RamKeeper Modification for Apple IIGS 1 Meg (Rev. 3 Motherboard)

Apple IIGS Models

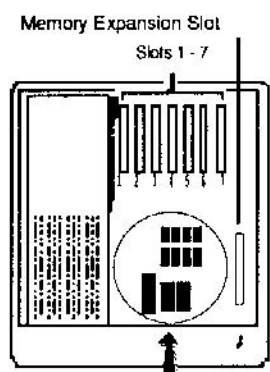
Compare your IIGS' motherboard with the drawings below to determine which you have.

Earlier IIGS Motherboards
No memory chips,
1 ROM next to CPU

Rev 3 IIGS Motherboards
8 memory chips,
2 ROMs next to CPU

Swap the 74F27
if you have the earlier IIGS

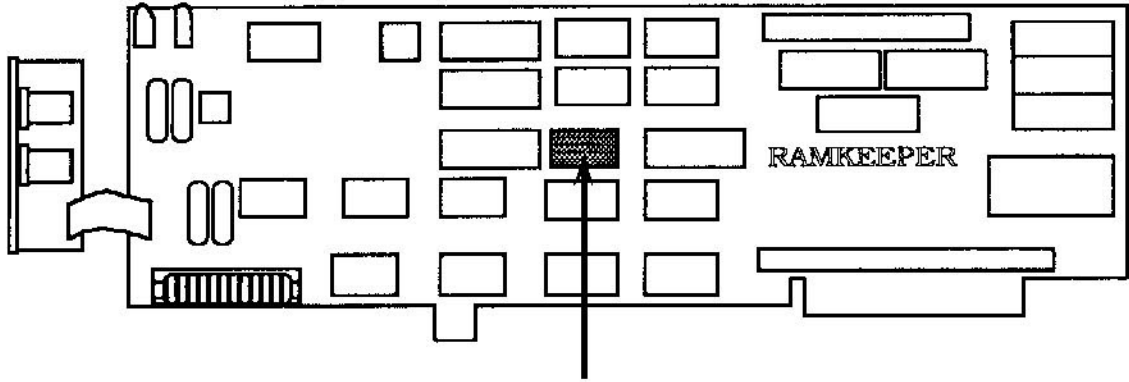
If you have the *earlier* GS, substitute the 74F27 chip shown below.

If you aren't familiar with the process of changing chips, refer to the "Chip Replacement Instructions" sheet included in the chip package.
